MEETING DATE: 10/20/2026**DEPARTMENT:** Development**AGENDA ITEM:** Bill No. 3132-26 Smithville Plaza Apartments Rezoning & Conceptual Plan

PLANNED DEVELOPMENT OVERLAY CONCEPTUAL PLAN

STAFF REPORT

Application for a Planned Development Overlay District Conceptual Plan

LANDSCAPE PLAN

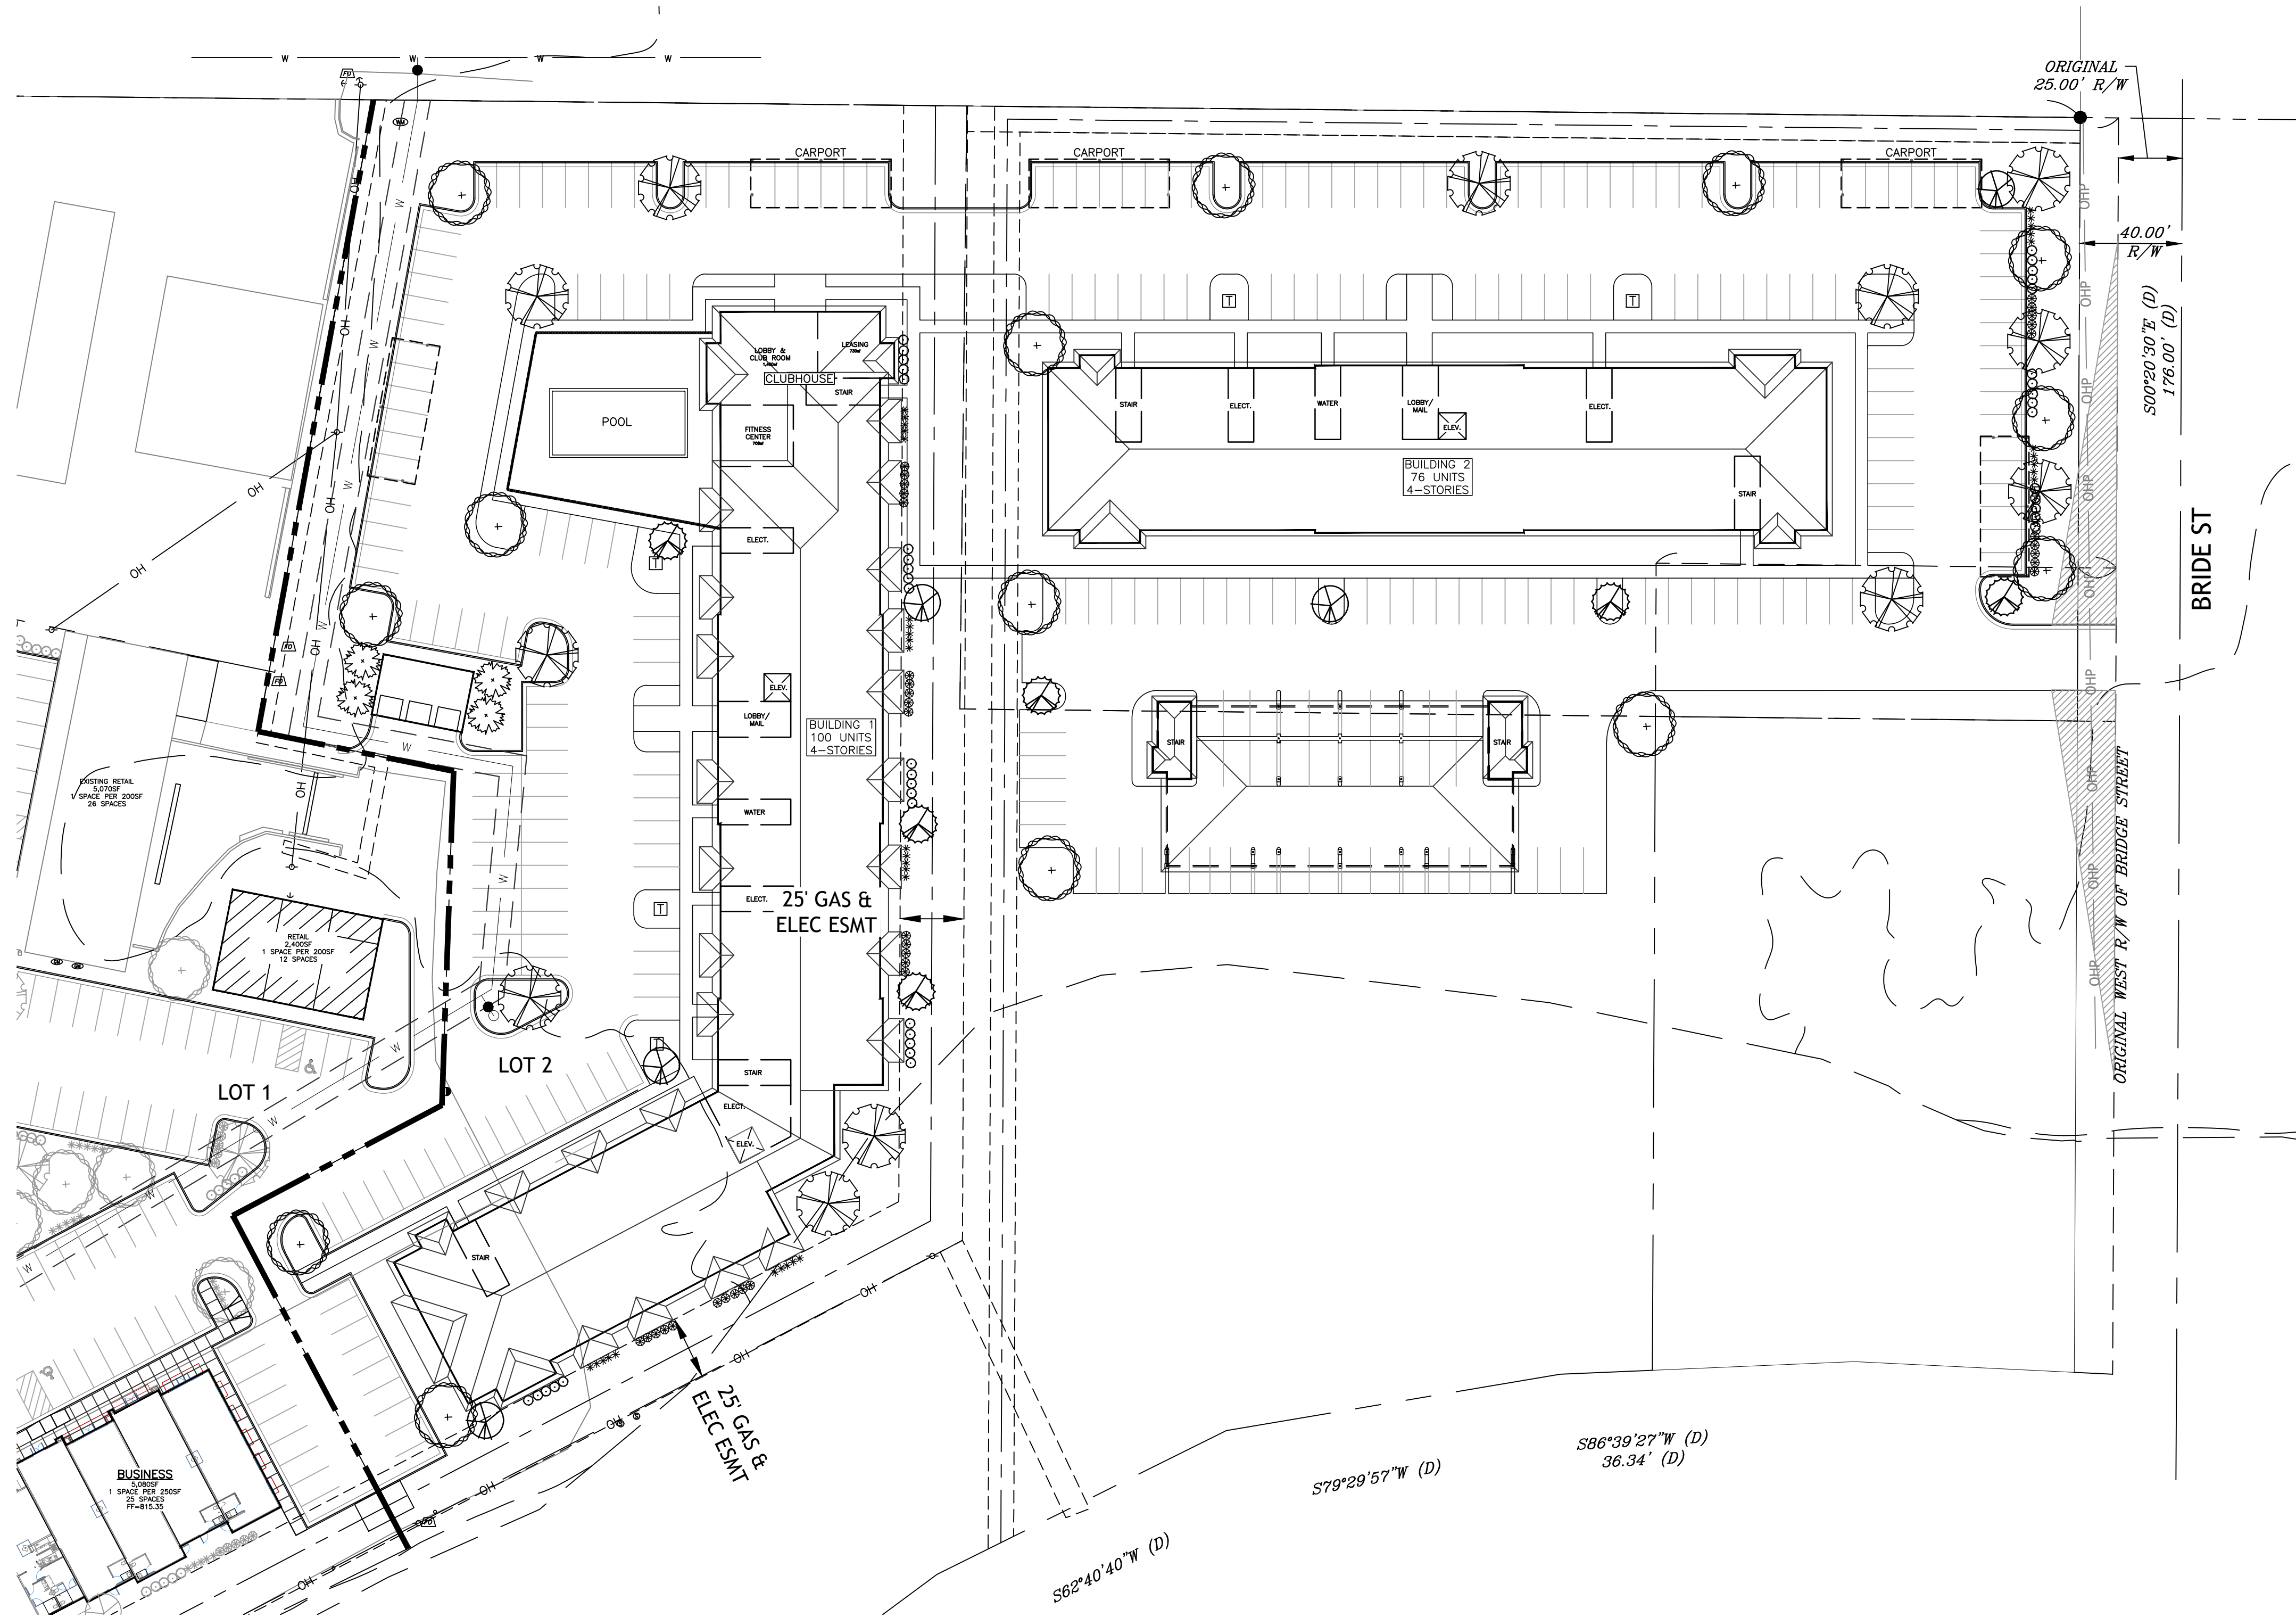
The landscaping plan addresses some plantings along the south façade of the western building similar to the retail area to the east, but leaves much of the remaining south facades open for view to and from the river. The eastern and western portions of the site will include substantial plantings to improve both the on-site and off-site views. The north façade will have limited plantings to address breaks in the parking area that faces the rear of the storage units to the north.

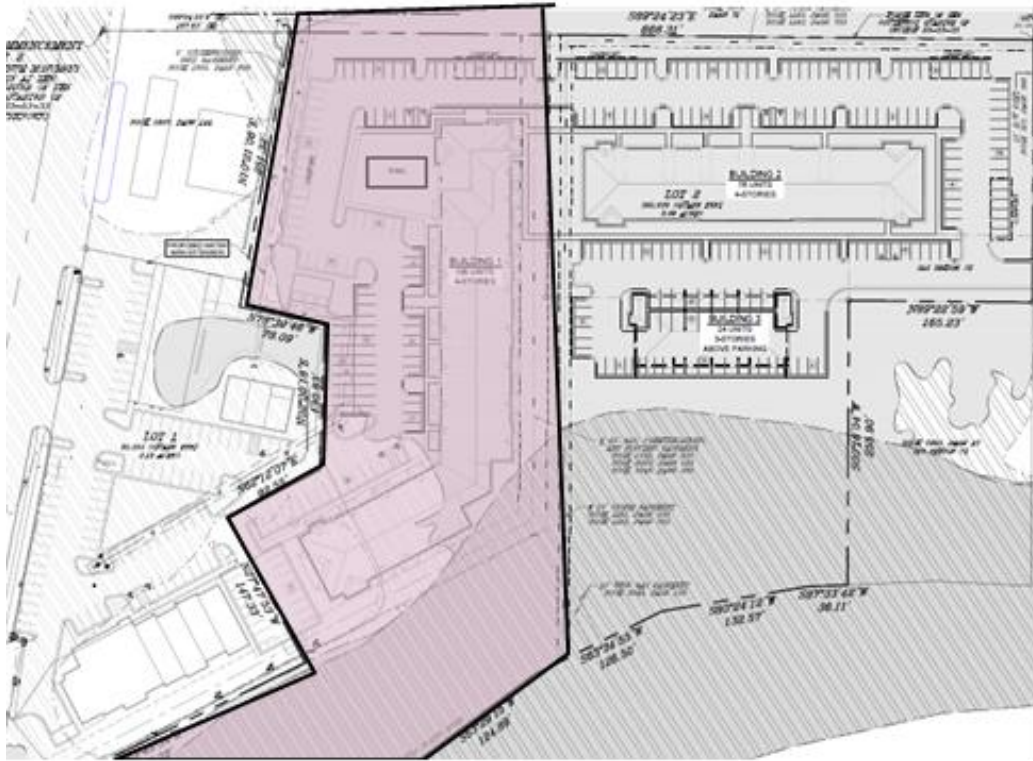
The applicant has submitted a rezoning request to change the B-3 and R-3 portion of the subject parcel to R-3 and then create a conceptual plan for development of a 200-unit apartment complex on the entire parcel. The subject parcel lies immediately east of the Smithville Plaza Retail development that fronts upon 169 Highway, and west of Bridge Street: south of the 169 Self Storage facility and north of Smith's Fork of the Little Platte River. The parcel lies west and north of the Patterson House Museum as well.

The applicant has submitted a site plan that provides 294 parking spaces (with additional co-location spaces in the retail area to the west) for a total of 200 units within 3 distinct buildings. This results in a parking density ratio of 1.47 spaces per unit. To justify this lower number of spaces, the applicant's traffic engineer evaluated the density requirements of both the International Traffic Engineers (ITE) and the Urban Planning Institute (UPI) and their studies and historical averages. The ITE numbers are also used in calculating the number of trips generated for each potential land use.

Staff recommends APPROVAL of the proposed district based upon the change meets the Comprehensive Plan recommendations.

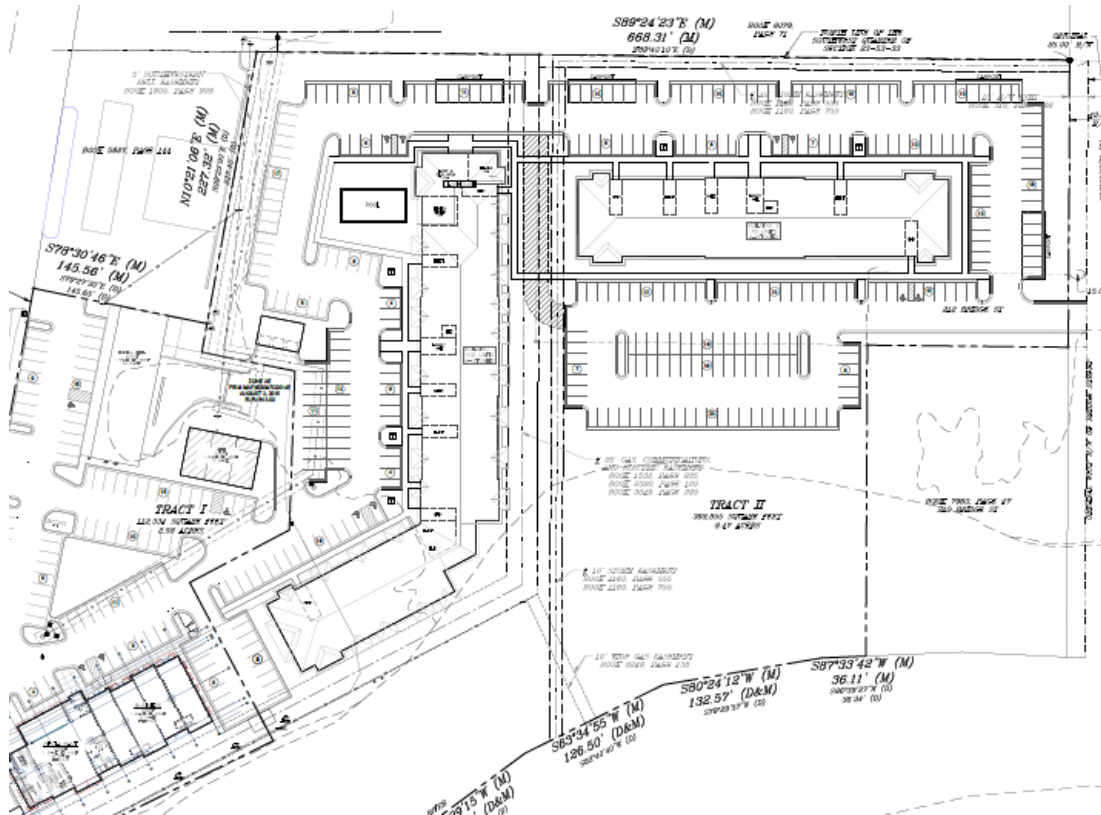
The applicant submitted for rezoning and a conceptual plan that was heard at the September Planning Commission meeting. It was recommended that both the rezoning and conceptual plan be approved by the Board of Aldermen. At the September 29, Board of Aldermen meeting, the matter was sent back to this body to reconsider the density of the units and the parking. The applicant has revised the original submission by deleting building 3 and increasing the parking spaces that were previously unavailable under that building. The updated plan now has 176 units in the buildings, with 300 parking spaces. They also reduced the number of 3 bedroom units and the submitted plan has a total of 298 bedrooms in the 176 units

EXISTING ZONING: The zoning was approved to change to R-3 on the east side of the extension of the Mill Street right of way line, making the entire parcel now R-3. The new updated layout and parking are shown below:

The applicant has submitted a revised site plan that now provides 300 parking spaces (with additional co-location spaces in the retail area to the west available) for a total of 176 units within 2 distinct buildings. This results in a parking density ratio of 1.7 spaces per unit. To justify this lower number of spaces, the applicant's traffic engineer evaluated the density requirements of both the International Traffic Engineers (ITE) and the Urban Planning Institute (UPI) and their studies and historical averages. The ITE numbers are also used in calculating the number of trips generated for each potential land use.

Staff recommends APPROVAL of the proposed district based upon the change meets the Comprehensive Plan recommendations.
